Access Compliance Report

Public Rights-of-Way

Intersection ID: 20571	Main Street: CAMERON_VALLEY_PY	Cross Street: FAIRVIEW_RD	Location: SE
ADA ID: 96F1424E323A	Ramp Type: PerpDiag	Initial Pass/Fail: Fail	Overall Compliance: No
		Severity Score: 12.5

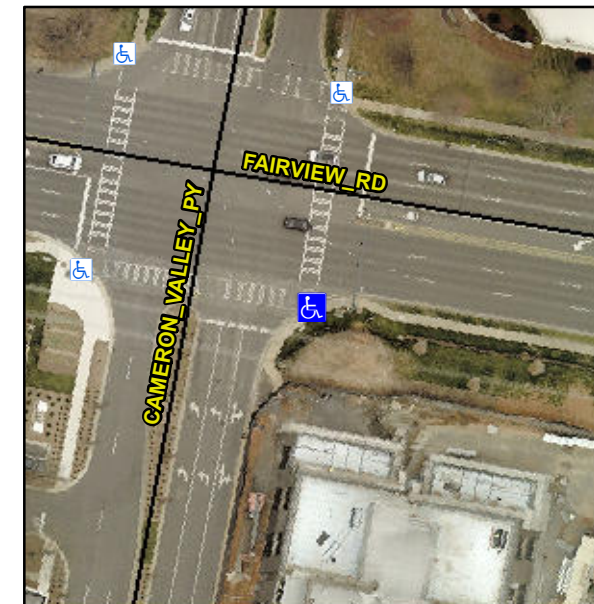
Not Found, R304.2.2

Compliance	Description	Data	Compliance	Description	Data
N/A	Ramp Length (in)	30.0	No	Ramp Slope (%)	8.8
Yes	Ramp Width (in)	51.5	Yes	Ramp XSlope (%)	1.2
N/A	Flare Type LT	N/A	N/A	Flare Type RT	N/A
N/A	Flare Slope LT (%)	N/A	N/A	Flare Slope RT (%)	N/A
N/A	Flare Traversable LT?	N/A	N/A	Flare Traversable RT?	N/A
N/A	Landing Length (in)	N/A	N/A	DWS Provided?	N/A
N/A	Landing Width (in)	N/A	N/A	DWS Contrast?	N/A
N/A	Landing Slope (%)	N/A	N/A	DWS Length (in)	N/A
N/A	Landing X Slope (%)	N/A	N/A	DWS Full Width?	N/A
N/A	Landing Curb? (Y/N)	N/A	N/A	DWS Offset (in)	N/A
N/A	Shared Landing?	N/A			
N/A	Gutter Ponding?	N/A	N/A	Gutter Slope (%)	N/A
N/A	Gutter Lip Ht (in)	N/A	N/A	Gutter X Slope (%)	N/A
N/A	Painted X Walk1?	Yes	N/A	Painted X Walk2?	Yes
	X Walk 1 Direction	To NE		X Walk 2 Direction	To NW
N/A	X Walk 1 Width (in)	105.0	N/A	X Walk 2 Width (in)	105.0
	X Walk 1 Slope (%)	0.1		X Walk 2 Slope (%)	0.5
	X Walk 1 X Slope (%)	0.7		X Walk 2 X Slope (%)	0.1

Remove & Replace Curb Ramp With Two New Directional Ramps or Equivalent.
